Town of Kittery Maine Planning Board Meeting December 13, 2018

ITEM 1 – 19 Coleman Avenue – Shoreland Development Plan Review

MEMORANDUM

FINDINGS OF FACT
For 19 Coleman Avenue
Shoreland Development Plan Review

SHEET TITLE: -PROPOSED-
 Elevations
 Front - Back
 Left - Right

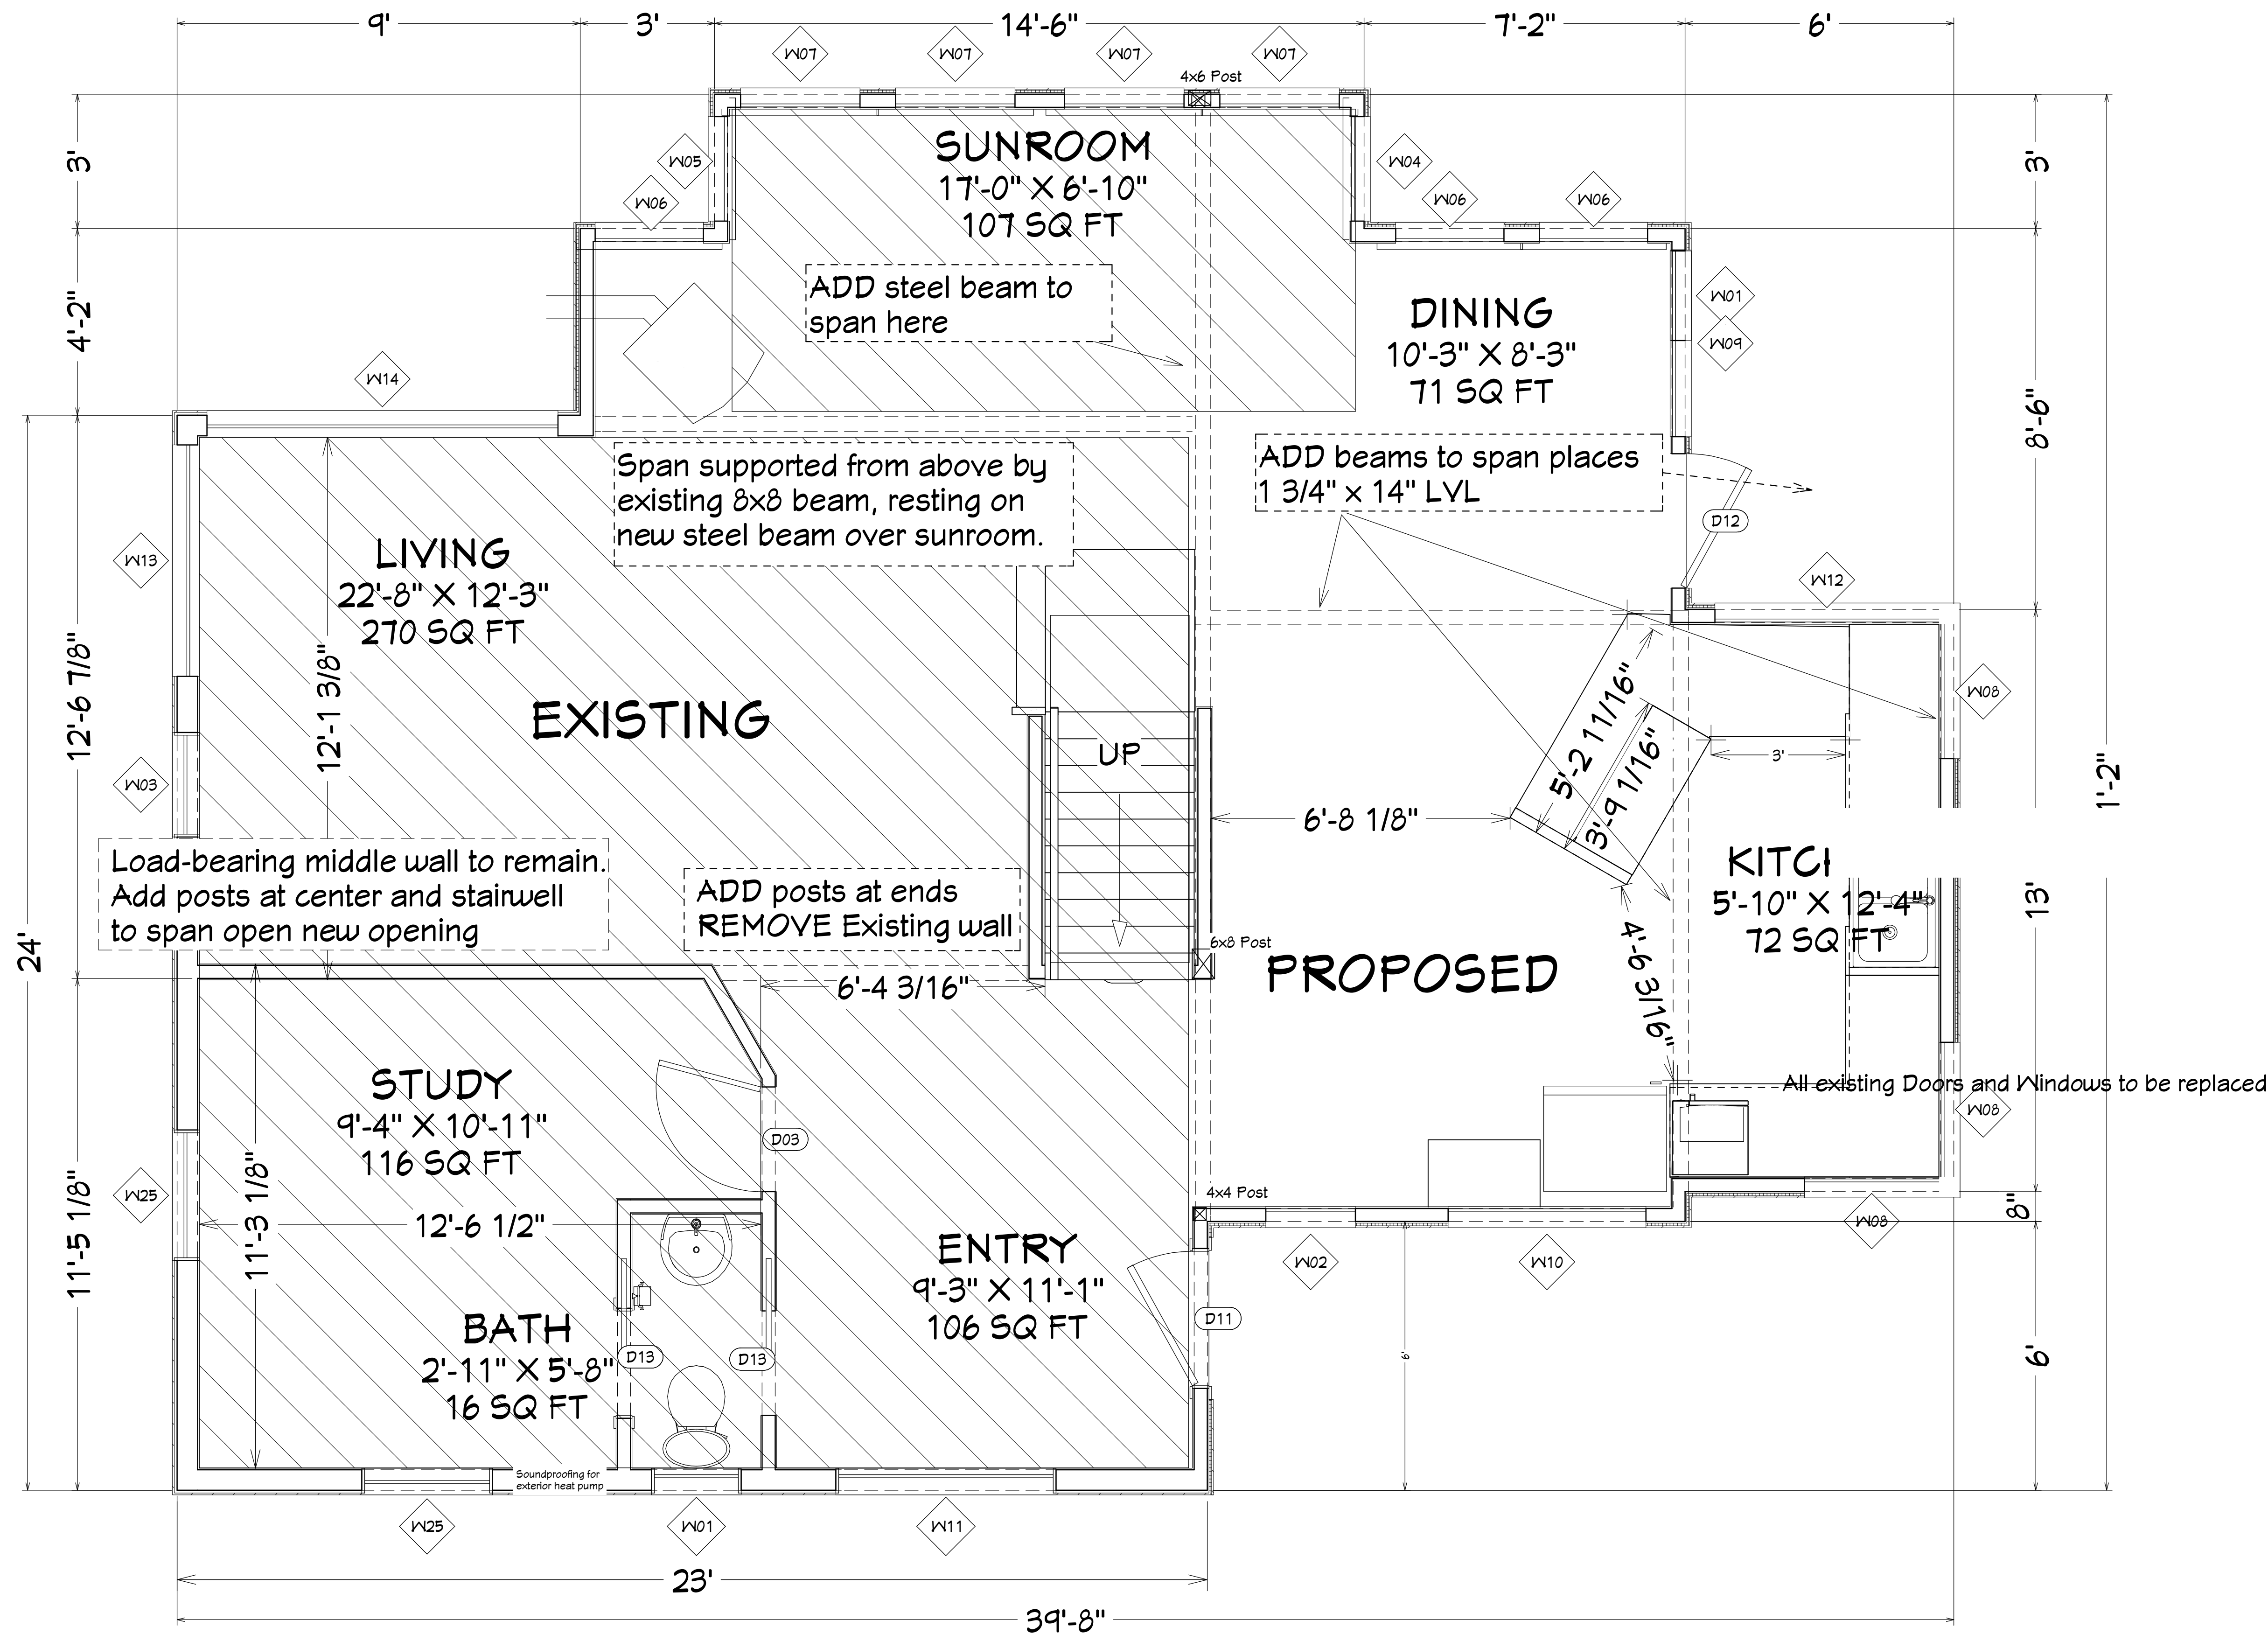
- i. Revised plans have been submitted that establish within 25' of the HAT the existing height of the porch is 13' and the proposed changes will not exceed 13.1'.

- iii. The maximum height of the dwelling is limited to no higher than the existing structure which is 22'8.5" feet.
 - iv. The applicant should consider requesting a waiver for the roof slope. There is an ordinance amendment before the Town Council to remove this requirement, however it has not yet been adopted.

These restrictions have been conveyed to the property owner, Ian Rex, and he has provided updated elevations and plans that conform to these standards. The portion of the structure within 25 feet will not be expanded in either footprint or height. The roof pitch for this portion will change to accommodate raising the subfloor in this portion of the structure to match the existing subfloor elevation for the rest of the first floor of the structure and still allow sufficient head room inside. Then applicant is requesting a waiver to the 8:12 roof pitch requirement so as to allow this change, without raising the height of this portion of the structure. The remainder of the structure outside 25 feet from the normal high-water line will match the existing height of the structure and the footprint expansion does not make the structure more nonconforming than currently exists.
